HPC Staff met with George Pfeifer and Mike Killa of Authentic Construction on June 10, 2015 to discuss the proposal for a three stall garage at the alley. Staff suggested that the proposed garage be re-oriented to the existing historic driveway to avoid adverse impacts to the historic alley wall. The applicant submitted plans that reflected staff's recommendation for a driveway oriented garage as an Option 2 with their December 22, 2015 application, but indicated that Option 1 plans were being put forward for review.

Freestanding garage on property at 389 Portland Avenue St Paul

SPECIFICATIONS FOR A PROPOSED GARAGE

LOT PLAN WITH GARAGE ENTRY AT FRONT

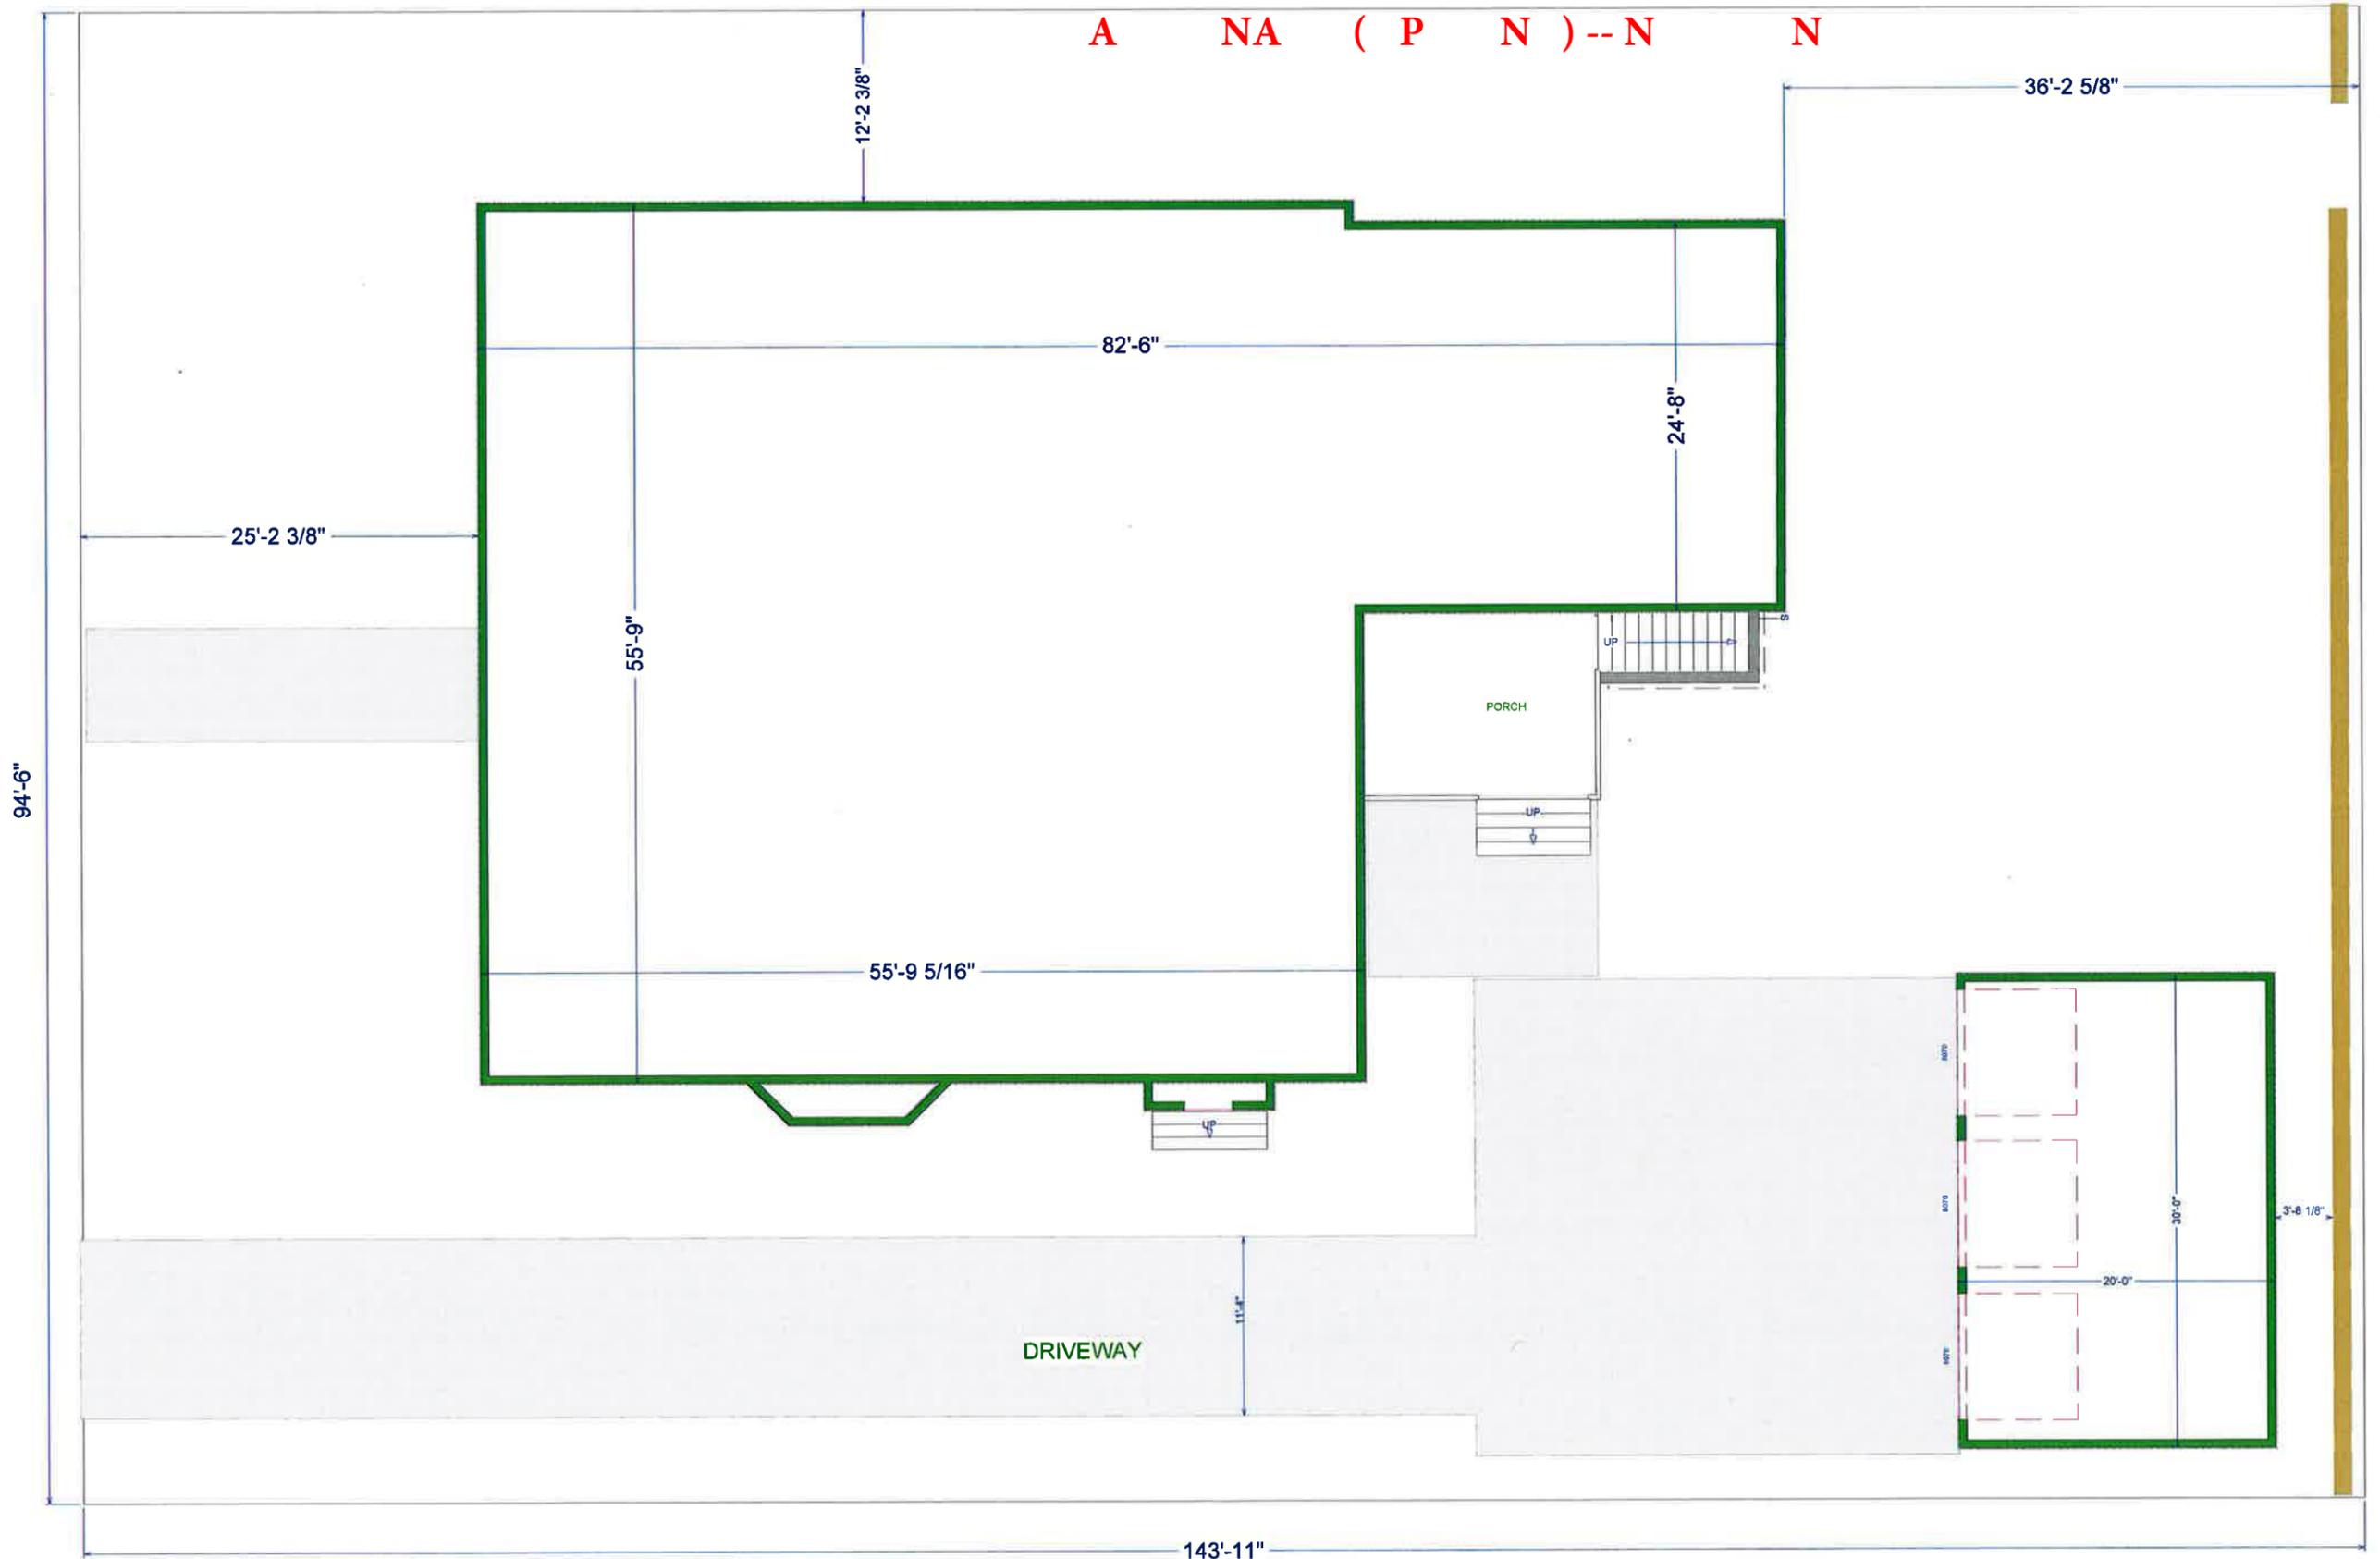
8. **Sec. 74.65 (f)(3) Garages and Parking:** The guidelines state that *if an alley is adjacent to the dwelling, any new garage should be located off the alley. Where alleys do not exist, garages facing the street or driveway curb cuts may be acceptable*. While there is an alley adjacent to the property, the historic brick alley wall would be altered in order to site the new garage to be accessed from the alley. Aerial photographs from 1923, 1945, and 1953 show a driveway on the property accessed from Portland Avenue with a circular turn-around in the rear yard during the period of significance (1858-1930). This demonstrates that, historically, carriage and auto use on the property was oriented at Portland Avenue, rather than the alley. Currently there is a cement block decorative wall separating the driveway from the rear yard. A photograph from 1973 demonstrates that the decorative wall was not present until after that time and outside the period of significance. There are no City records relating to an application or approval of the wall. The driveway is currently designated as the apartment unit parking spot in the side yard. The proposed siting of the garage does not relate to the historic auto use on the property.

Lane and other brick and cobblestone alleys in the district. The proposal to remove 30 feet of the brick wall (1/3 of the total wall length) to accommodate the garage does not comply with the guidelines and would result in the loss of historic fabric.

10. **Sec. 74.64(2)** The removal of a portion of the brick alley wall would result in the loss of *historic material* and an *original character of the site*.
11. The design and materials of the proposed three-stall garage generally comply with the guidelines and will not adversely affect the program for preservation and architectural control of the Historic Hill Heritage Preservation District (Leg. Code 73.06 (e)).
12. The proposal to construct a new three-stall garage sited with access from the alley will adversely affect the program for preservation and architectural control of the Hill Historic District (Leg. Code 73.06 (e)) as it will result in the loss of historic fabric and the alteration of the historic wall.

Based on findings 8, 9, 10, and 12, staff recommends denial of the proposal. Staff would recommend approval if the proposed garage was sited to be accessed by the existing driveway and curb cut on Portland Avenue and not result in the loss or alteration of historic material or features.

387 PORTLAND GARAGE DOOR DETAIL

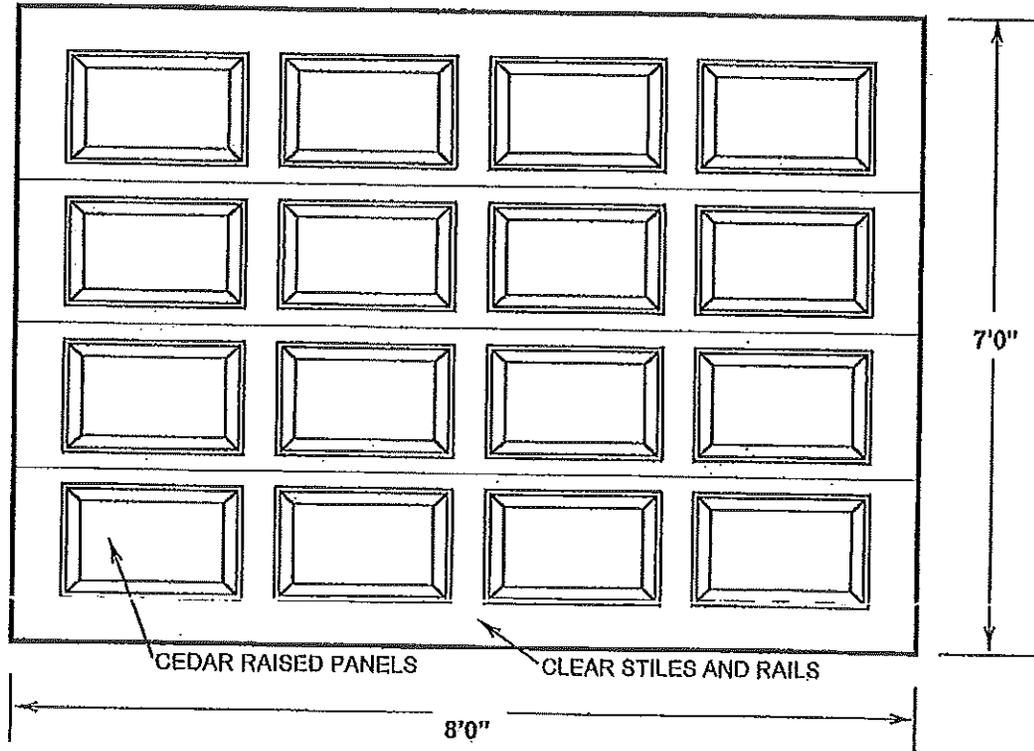
The garage doors are appropriately styled, single paneled doors that would comply with the guidelines whether the garage is sited at the alley or at Portland Avenue. The finish on the garage doors was not submitted with the application.
